**JINDAL ALUMINIUM LTD.**  
**BANGALORE-560073 (INDIA)**

|                      | NAME           | DATE       |
|----------------------|----------------|------------|
| 10439                | 10439(ISSUE-3) |            |

| DESCRIPTION         | FLAT BAR                                 |

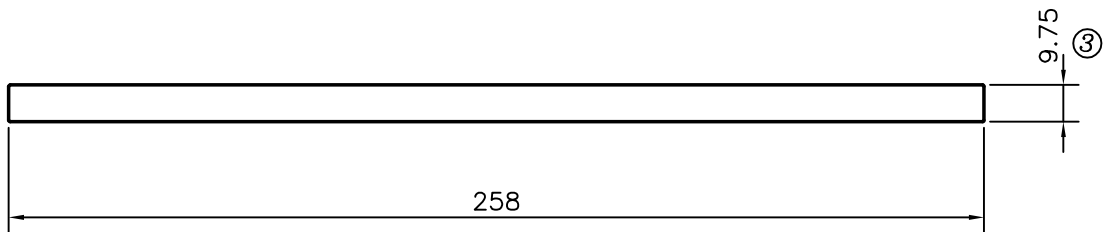
- ☞ TOLERANCE ADDED ON THICKNESS.

- ☞ THICKNESS CHANGED FROM 7.8 TO 9.75 mm.
- ☞ WEIGHT ALSO CHANGED FROM 5.433 Kg/M. TO 6.791 Kg/M.
